Revision		By	Date
	TALLGRASS EAST COMMERCIAL 2ND ADDITION STORM WATER DRAIN NO. 407			
	<h2>24 HEADWALL W-SOIL SAVER</h2>			
	GARY JANZEN, P.E. - CITY ENGINEER CITY OF WICHITA PROJECT NO. 468-85097			
		PROFESSIONAL ENGINEERING CONSULTANTS, P.A. 303 SOUTH TOPEKA WICHITA, KS 67202 316-262-2691 www.pec1.com		
Designed by	JAG, TBK	Job No.	31-15627-002	Sht. 15 of 23
Drawn by	BJS	Date	April 2016

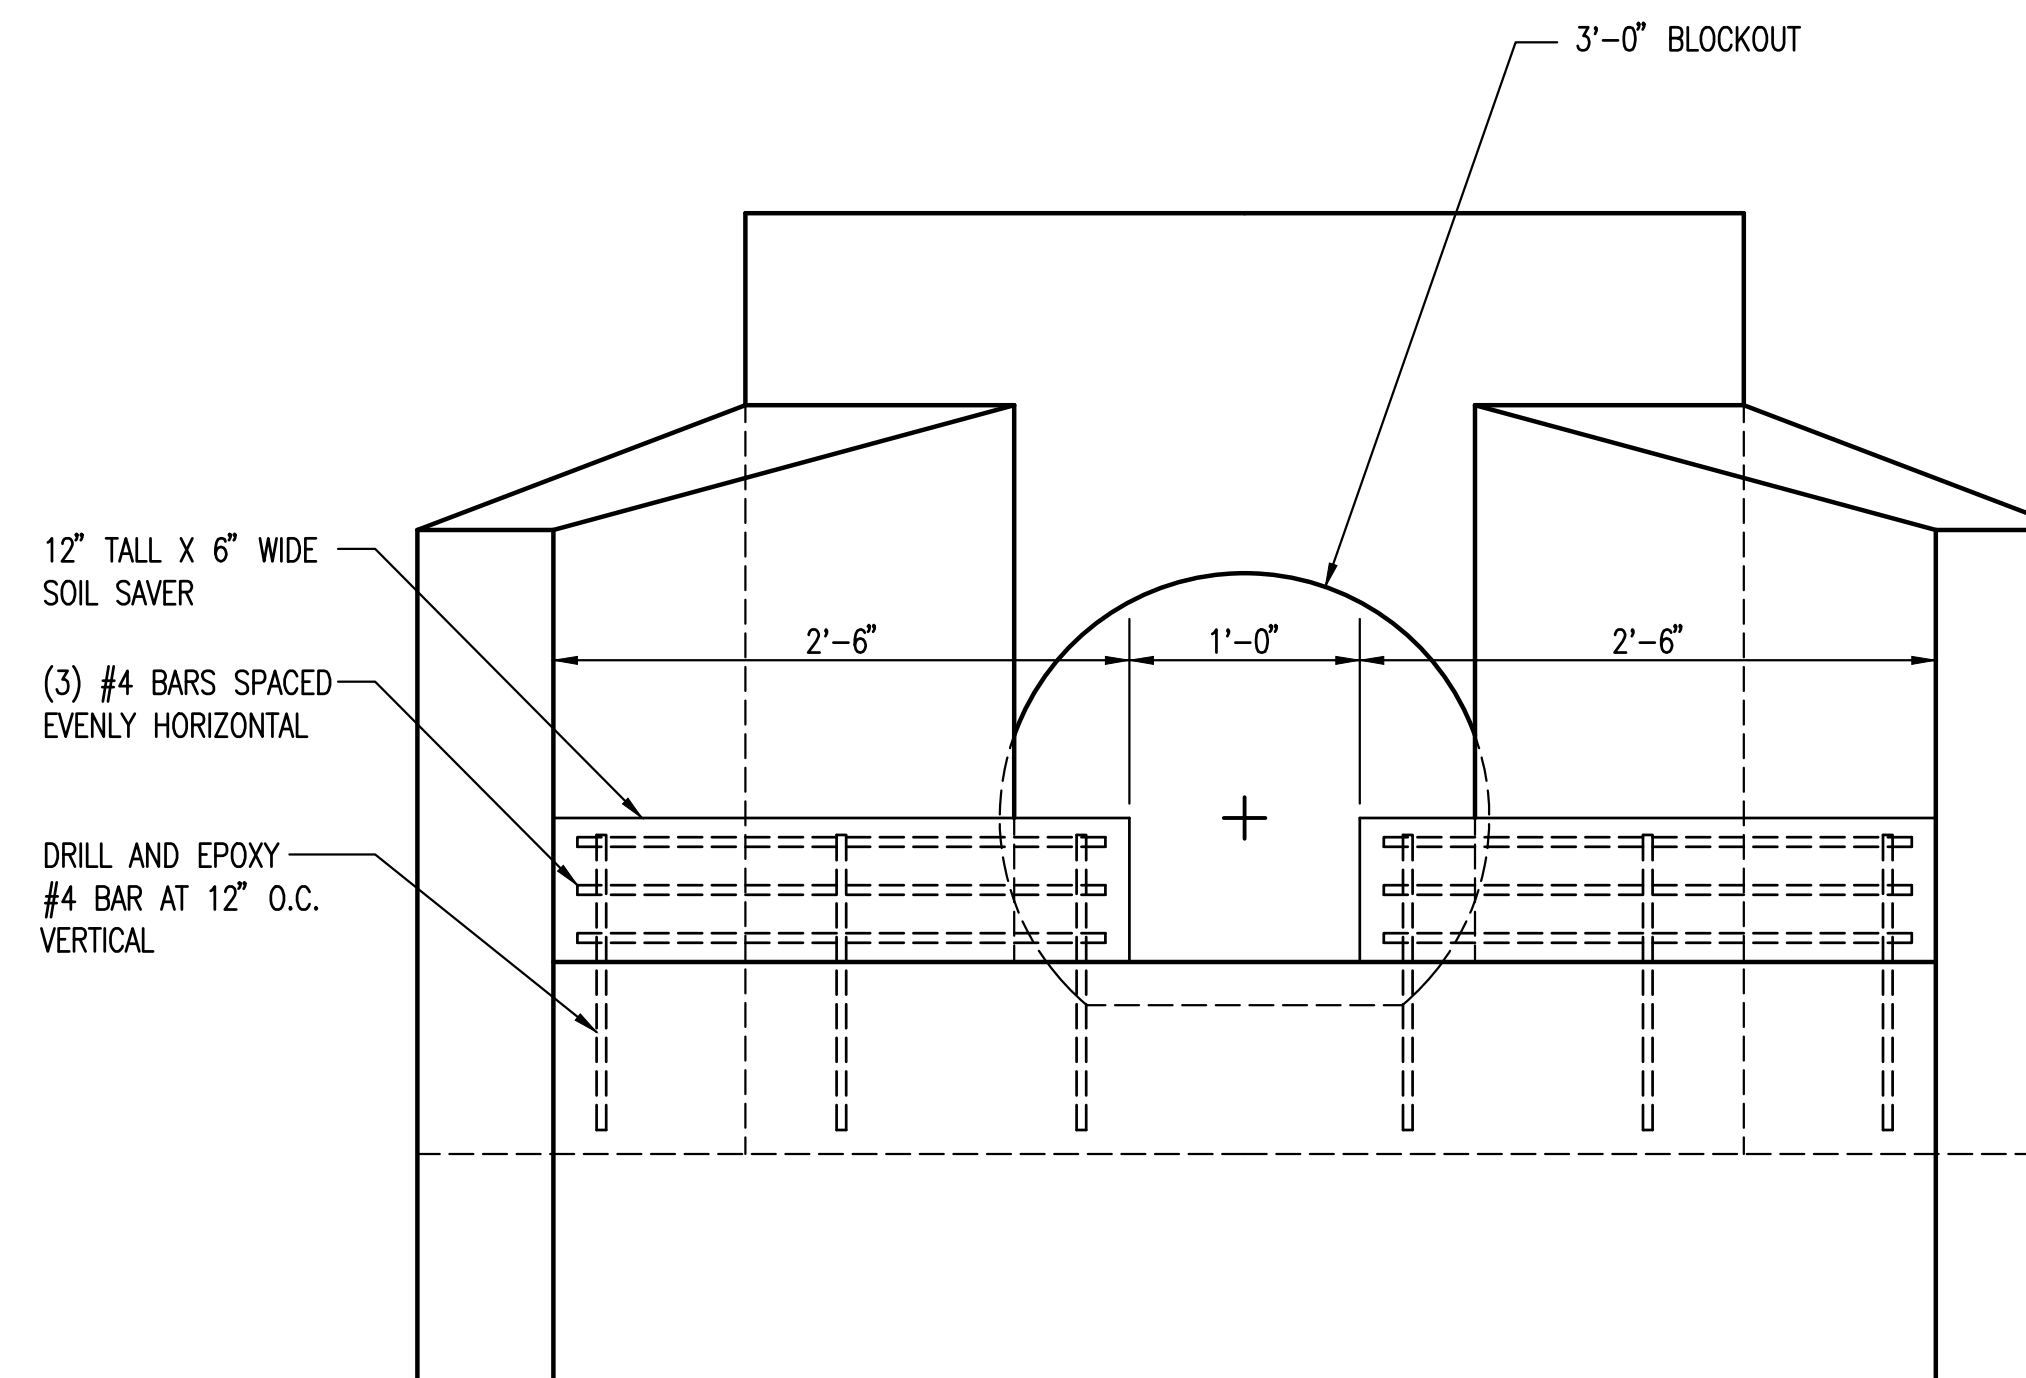
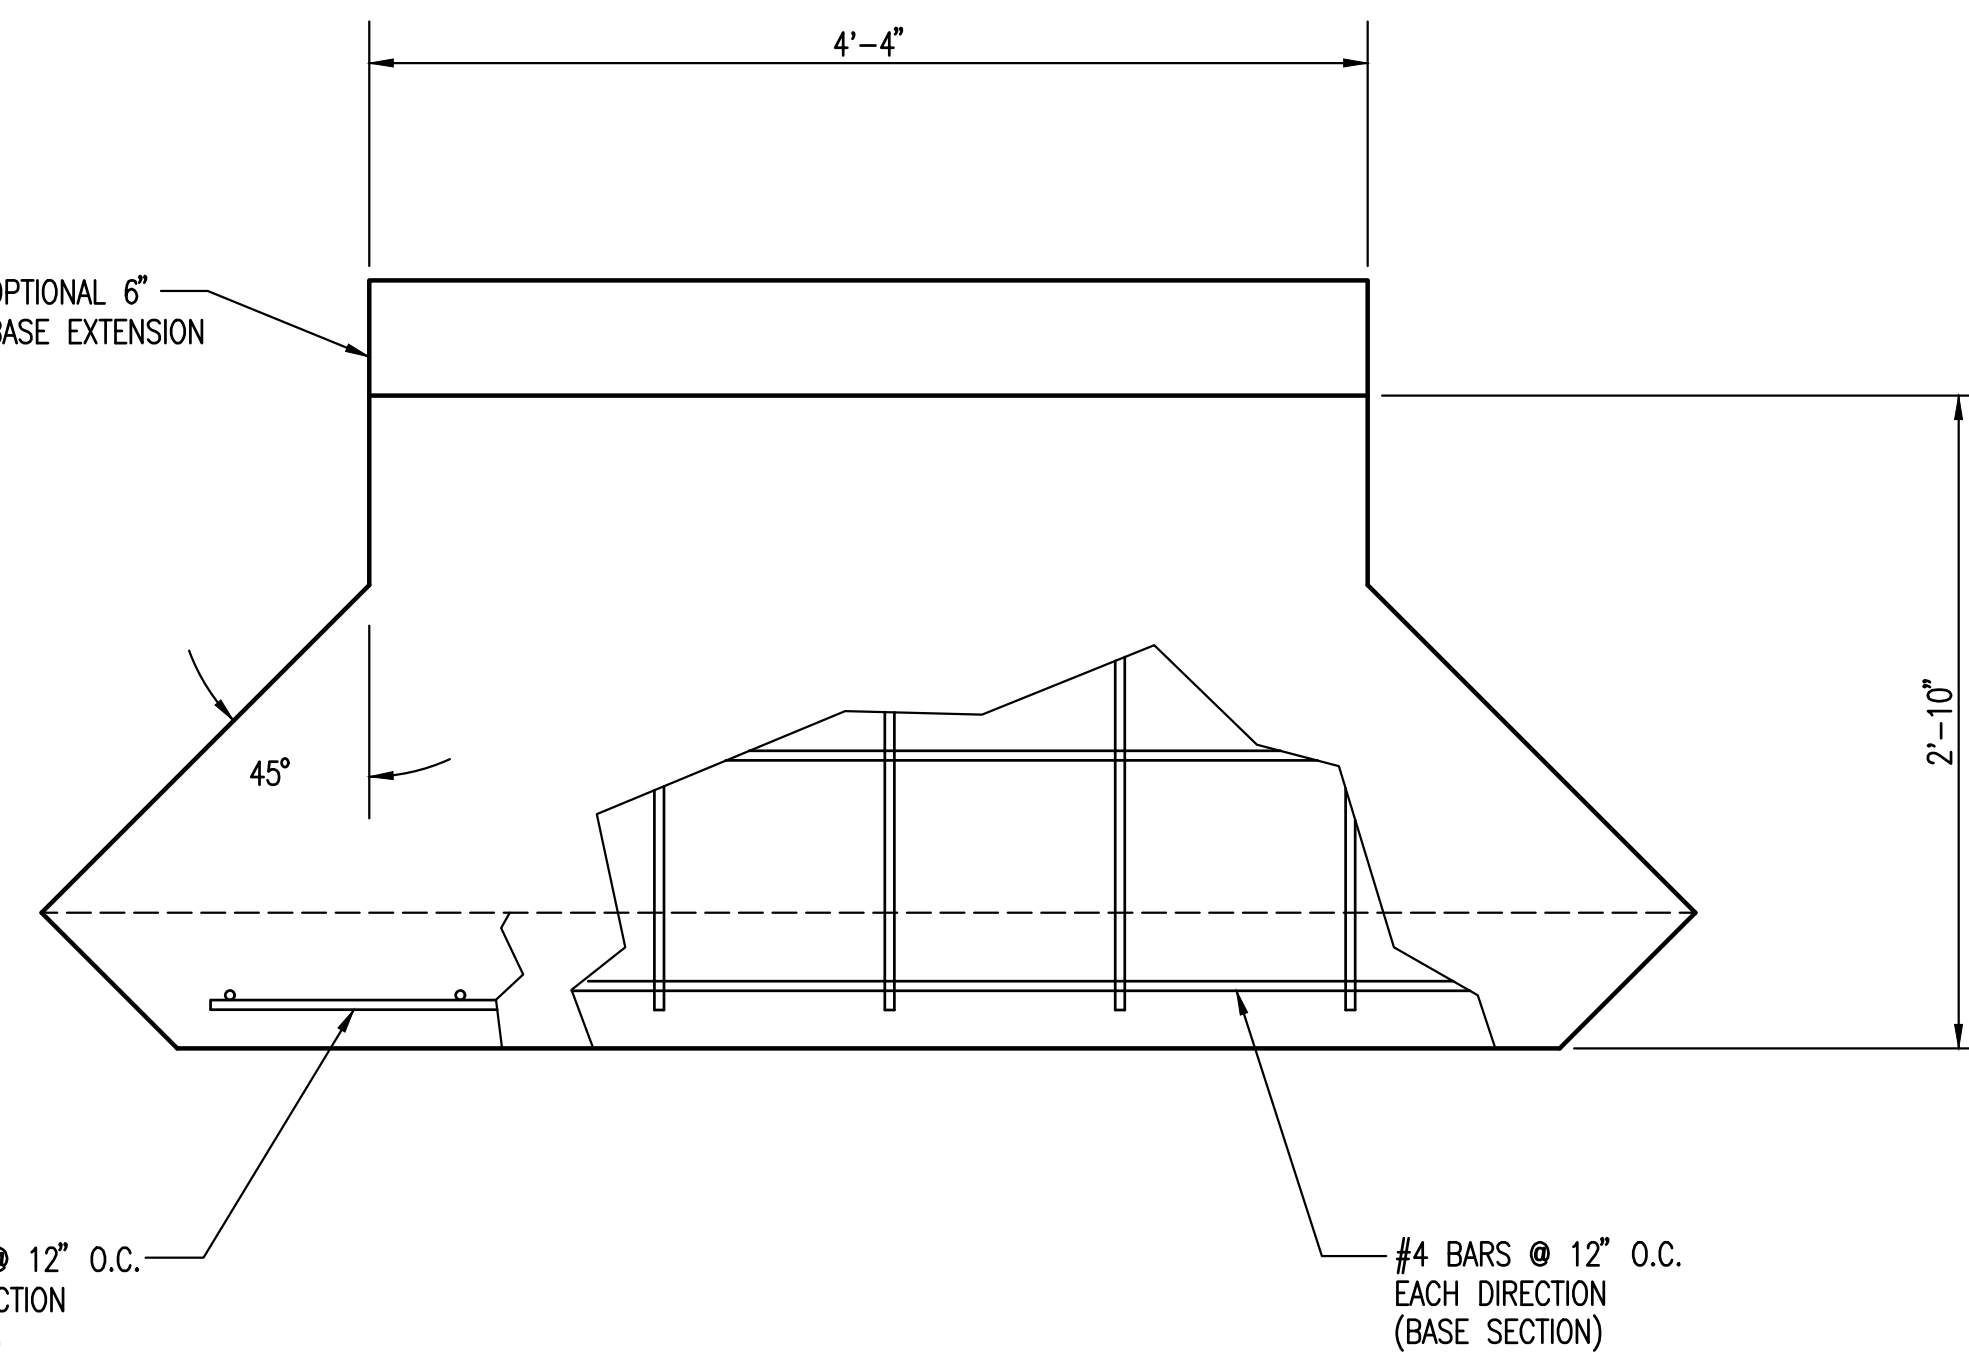
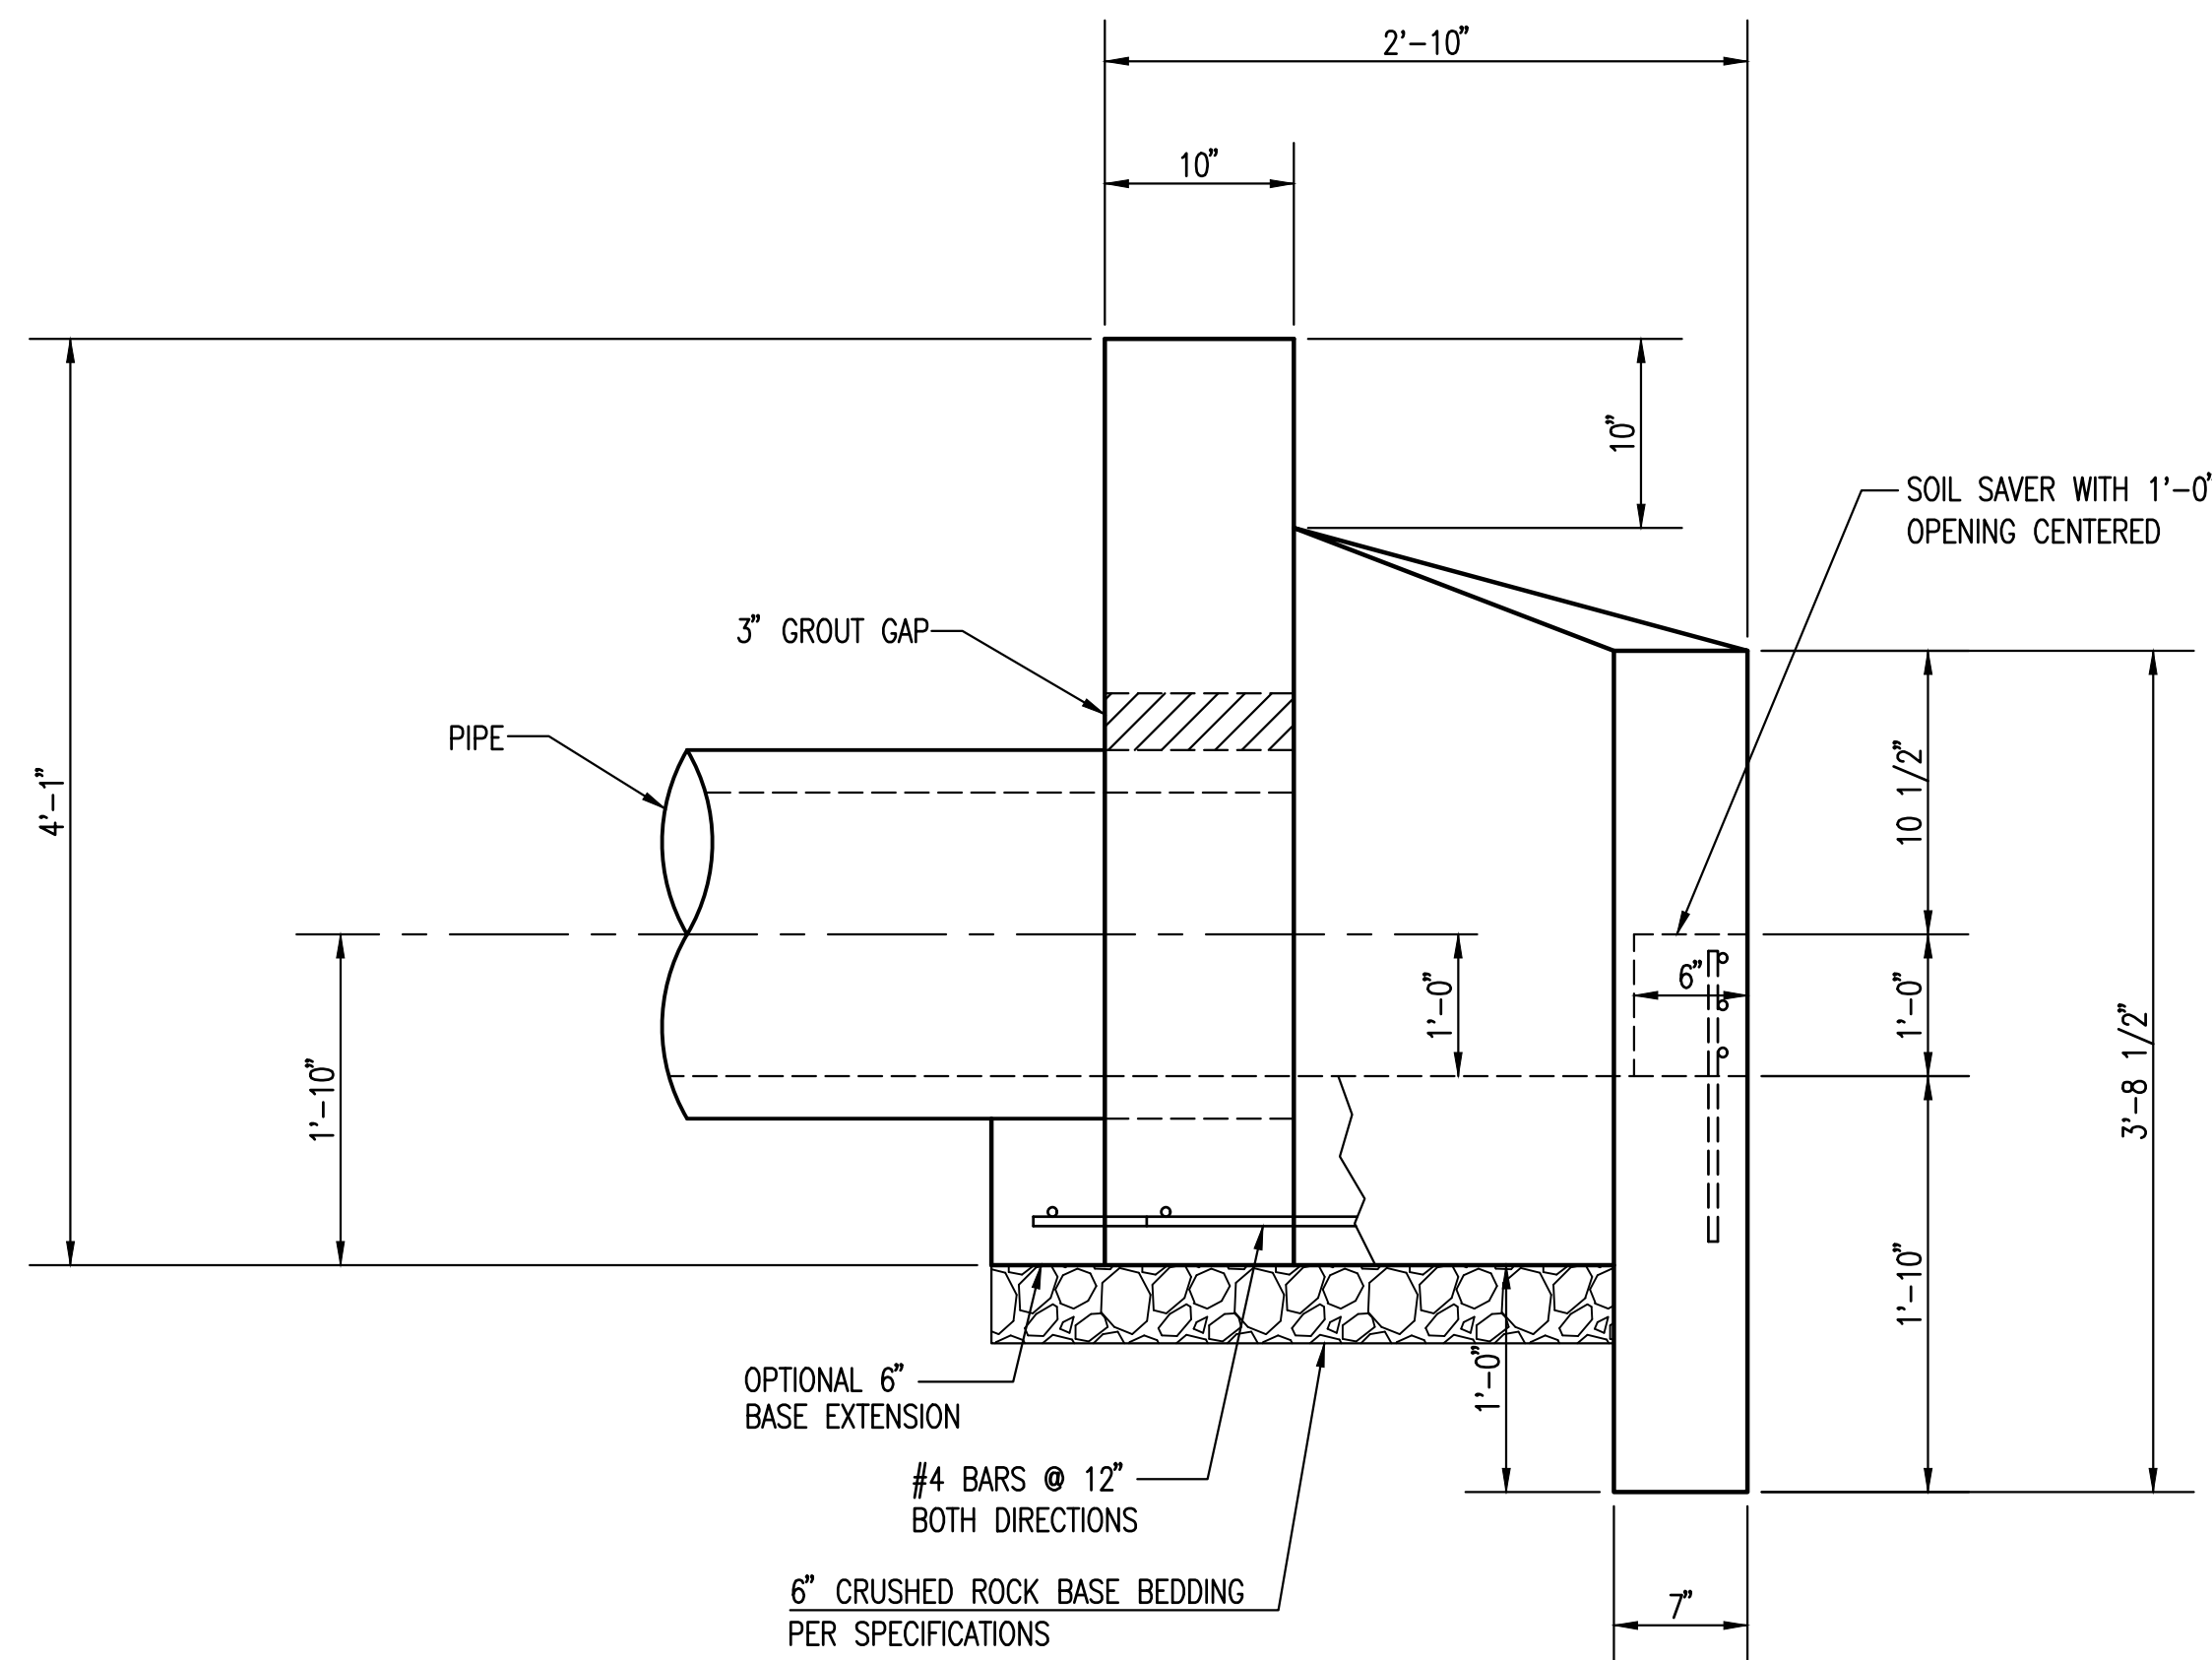
HEADWALLS, AS SHOWN, WILL NOT SUPPORT FLAP GATE.
